## DEVELOPMENT REVIEW BOARD

### Planning - Case Comments

**Project Name:** MDS Innovation Park II

**Request:** Alternative Landscape Plan

SHEET NO.  
LP108

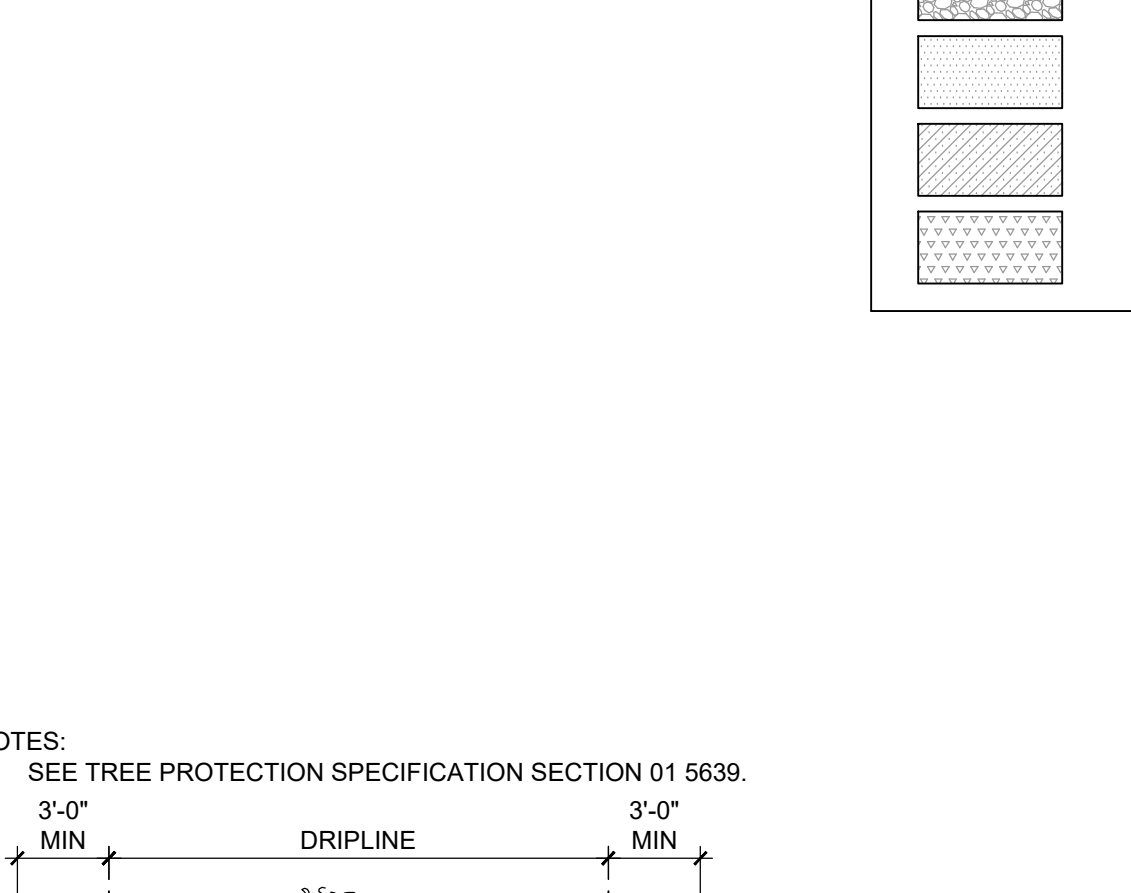
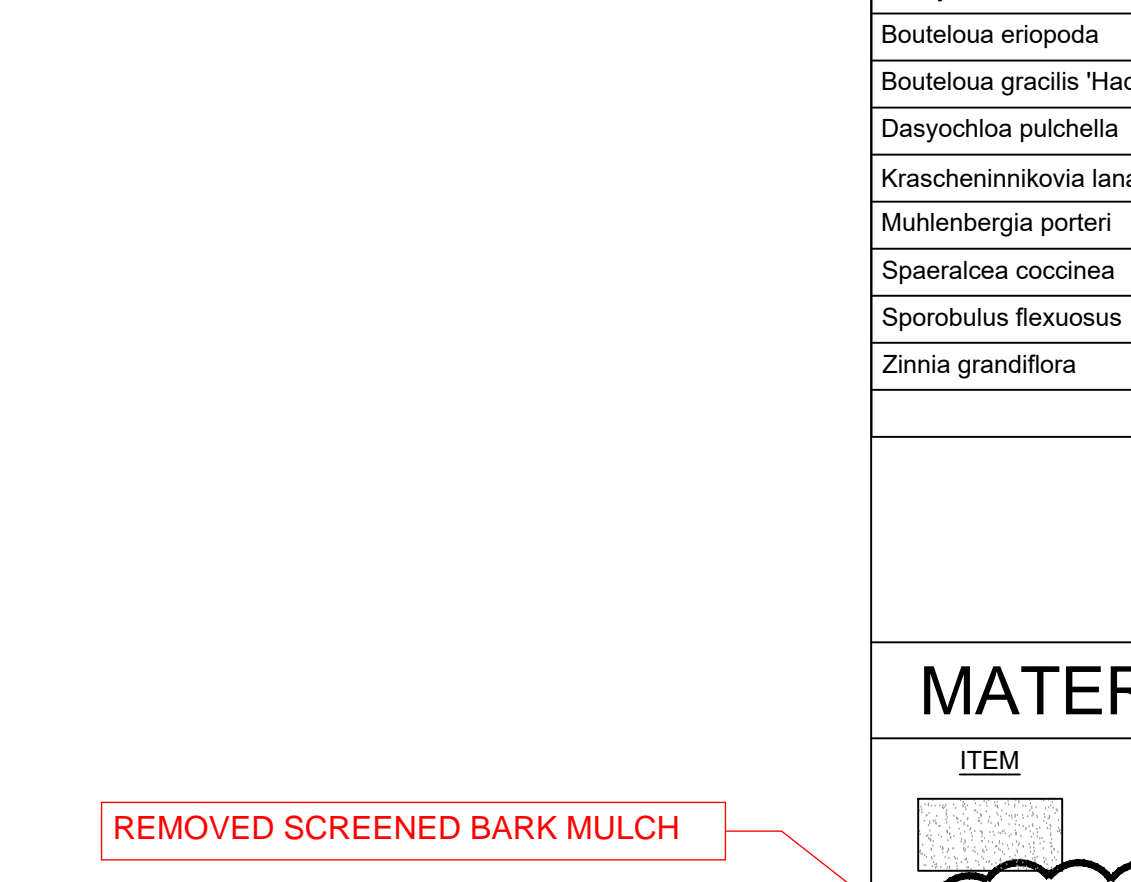
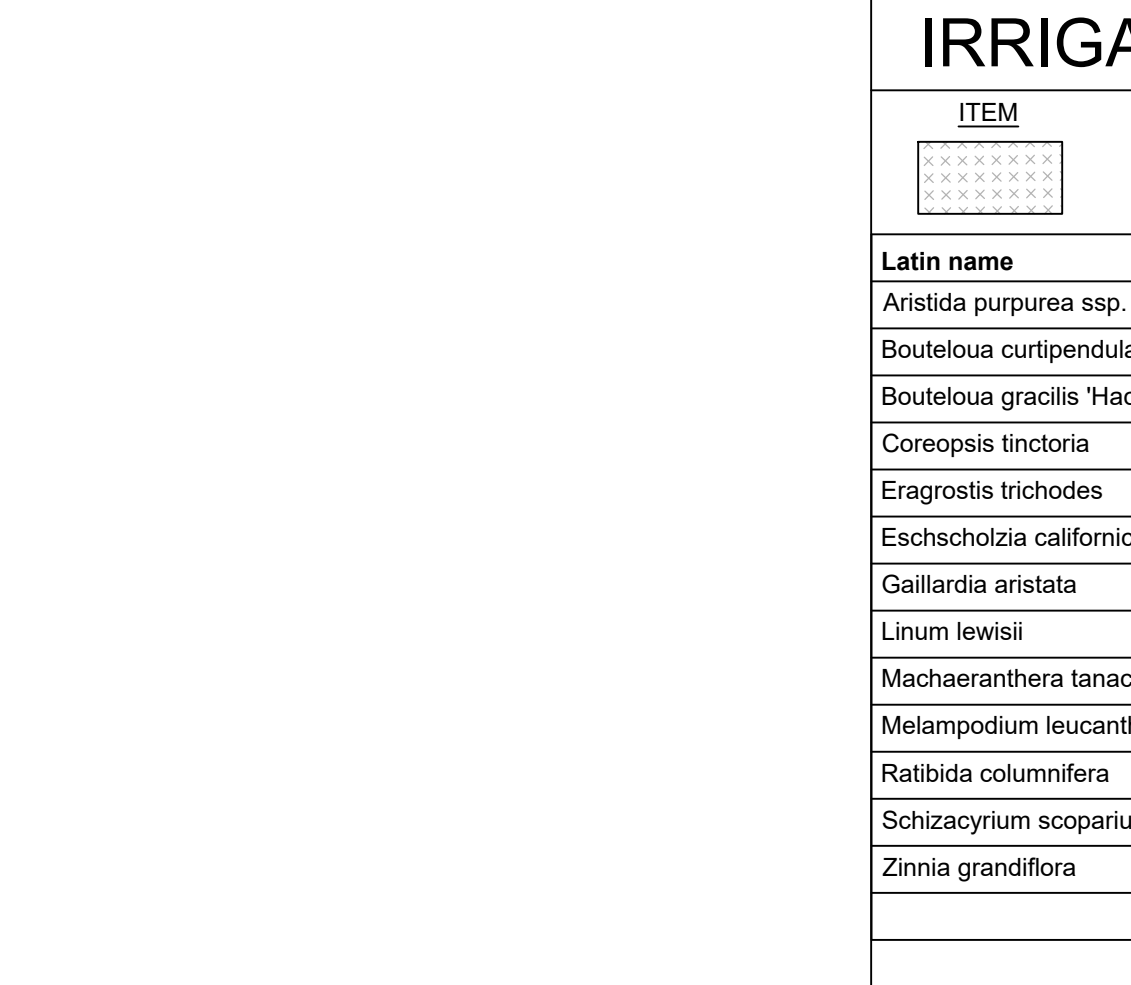
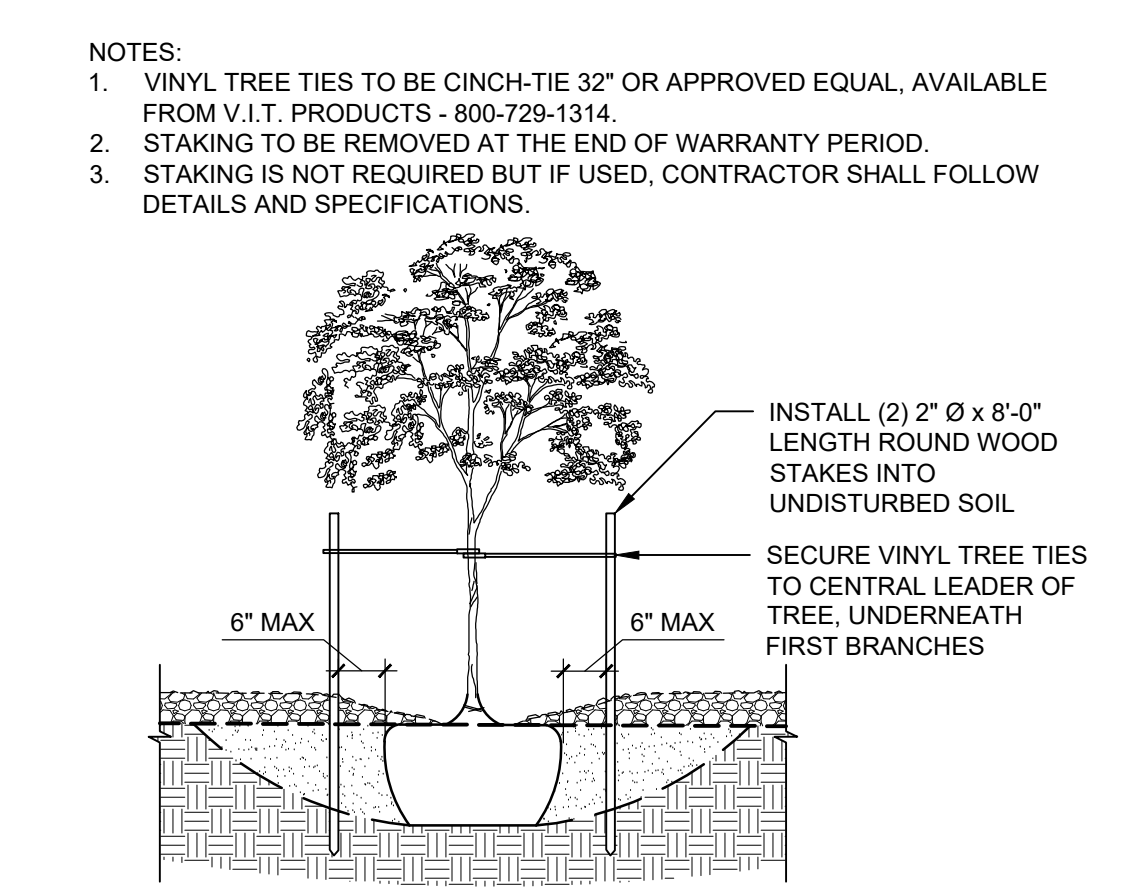
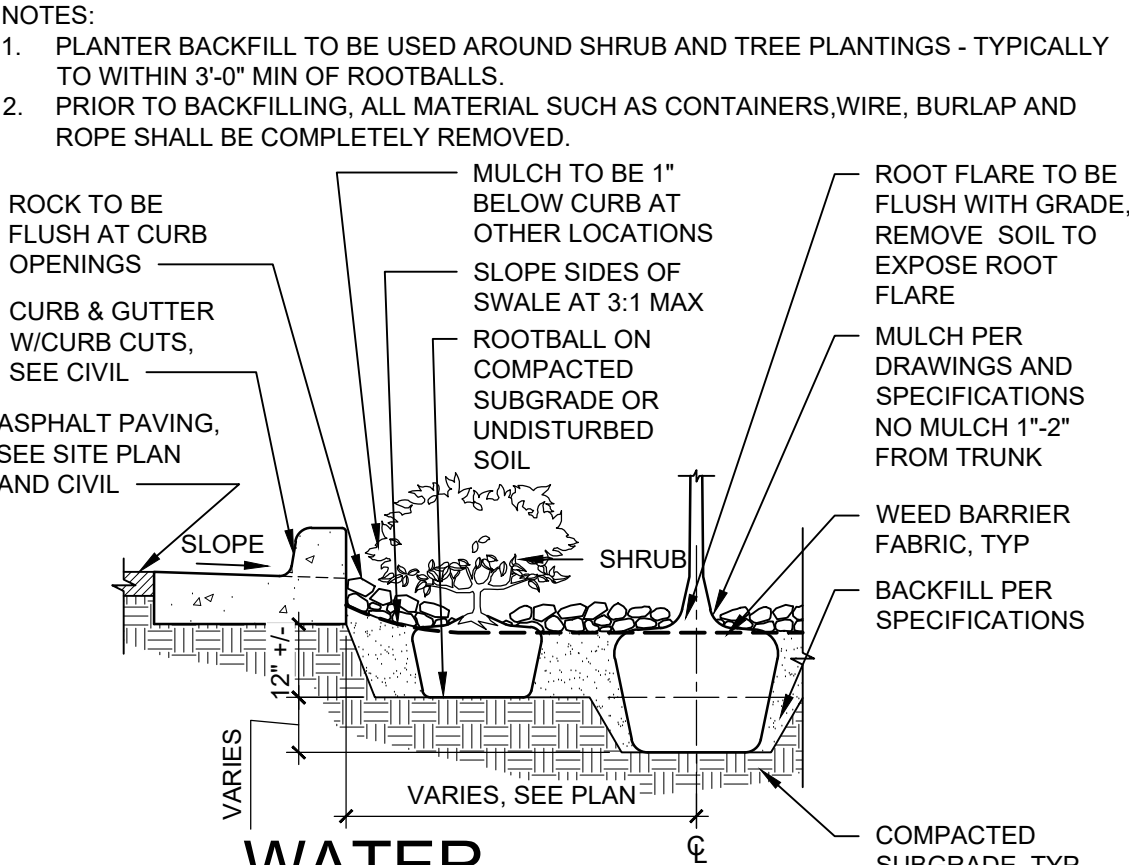
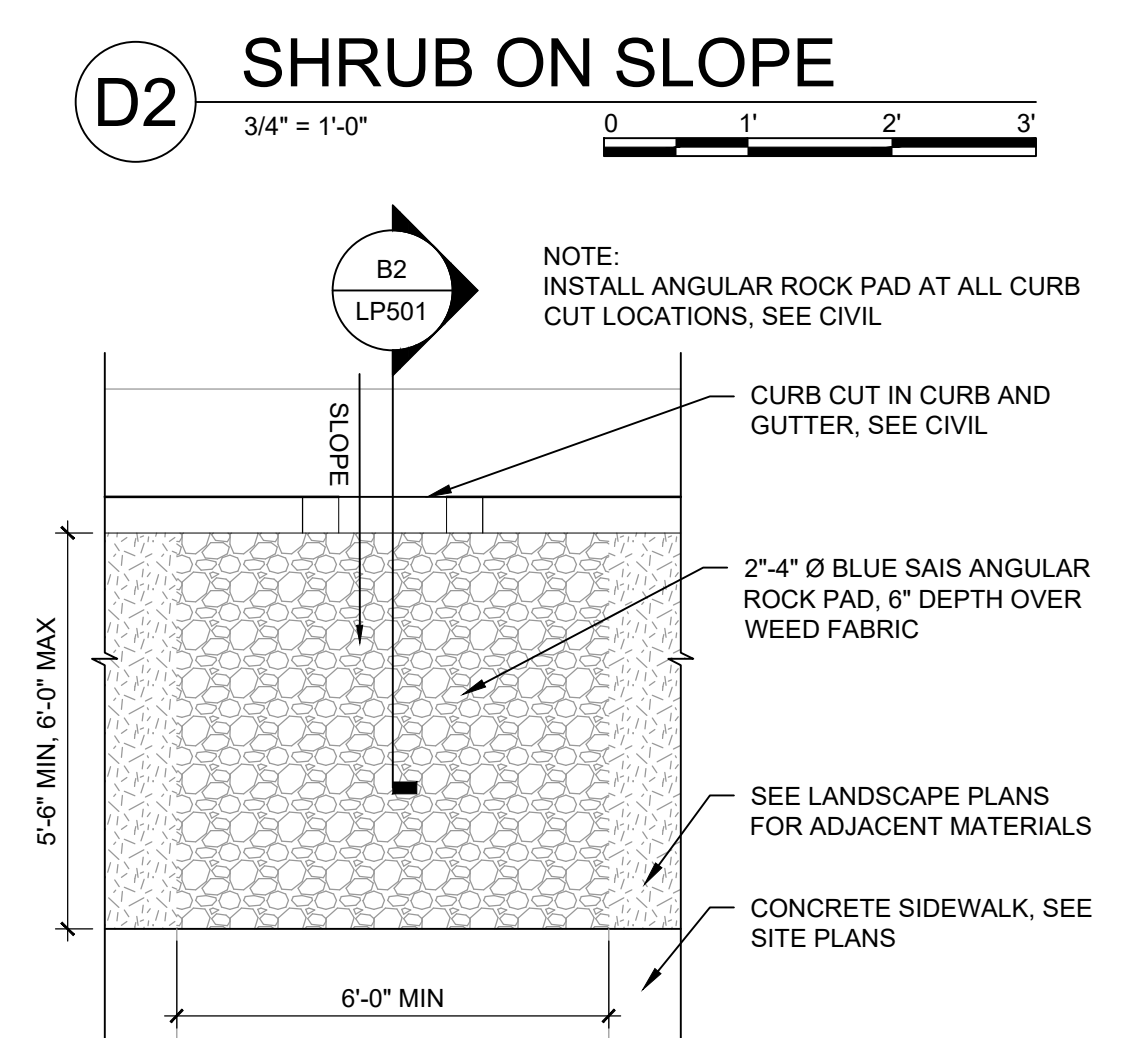
UPDATE NOTE

ADD NOTES

U. TREES SHALL NOT BE PLANTED WITHIN 10'-0" IN ANY DIRECTION OF THE CENTERLINE OF A SANITARY SEWER OR WATER LINE.

V. VEGETATION SHALL BE LOCATED AT LEAST 3'-0" IN ANY DIRECTION FROM FIRE HYDRANTS, VALVE VAULTS, HOSE BIBS, MANHOLES, AND FIRE DEPARTMENT CONNECTIONS.
